INDESIT company

Model type:
LV680DUOIX

Commercial code:
F029949

n1045083: Modification of filters on EVO3 60 cm dishwashers

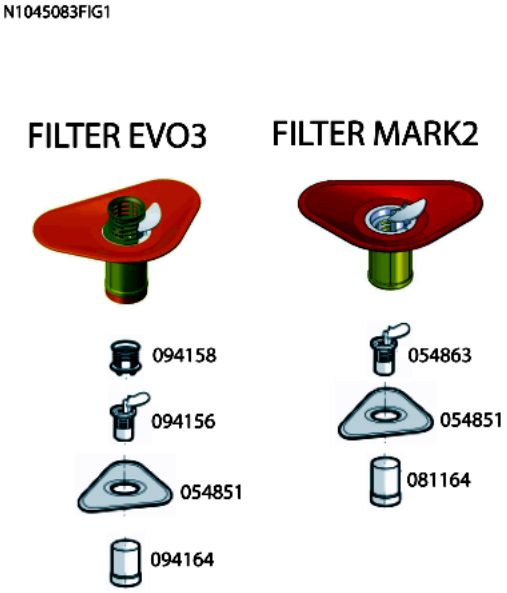
All dishwasher models affected by this modification have been equipped with the items listed below, in order to solve the drain pump clooging problem.

Introduction of:
Cylindrical plastic filter code 081164

Central filter code 054863

Elimination of:
Cylindrical plastic filter code 094164
Central filter code 094156
Central filter grid code 094158

The modification has been introduced progressively, starting from serial no. 40516.0001.

n1045085: Introduction of new litre counter turbine integrated on air-break.

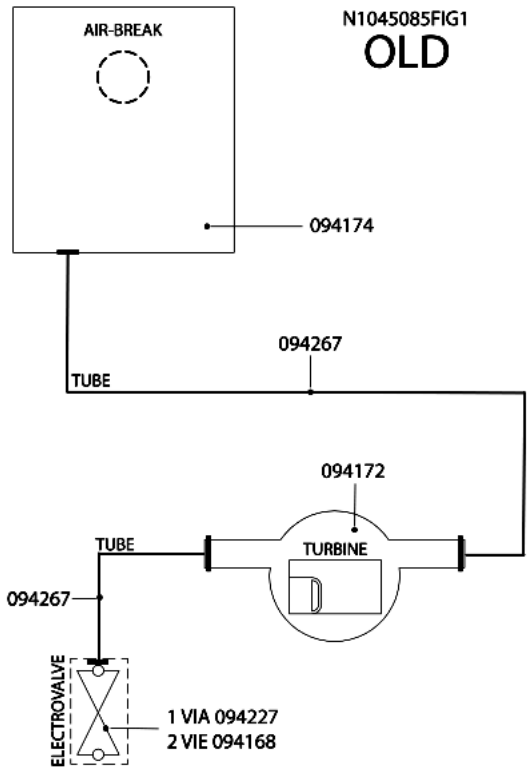
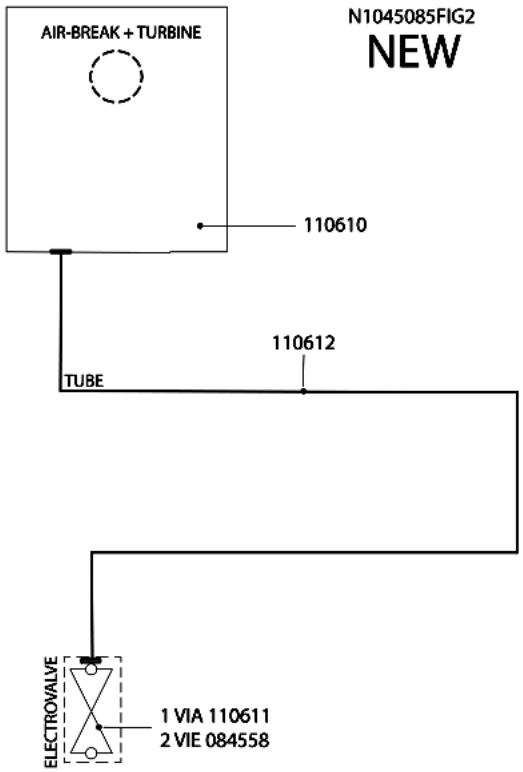
All dishwashers affected by this note have been equipped with a new litre counter turbine on the air-break.
Picture N1045085FIG1 illustrates the premodification structure, picture N1045085FIG2 the new structure.

Items affected by the modification.

AIR-BREAK:
new 110610;
premodification 094174;
the new item features a new integrated litre counter turbine and its water supply hose has a smaller diameter.

LITRE COUNTER TURBINE code 094172 has been eliminated.

SOLENOID VALVES:
new:
1-WAY code 110611;
2-WAY code 084558(Rohs 143737);
premodification:
1-WAY code 094227;
2-WAY code 094168;
the new solenoid valves have a smaller diameter drain hose fitting.

HOSES:
new solenoid valve hose/air-break code 110612;
premodification turbine hose/air-break code 094267;
premodification solenoid valve hose/air-break code 094267;
the new hose has a smaller internal diameter.

WIRING:
the litre counter turbine connecting cable is longer, but since the connector is the same, the new item can be used in place of the premodification one.
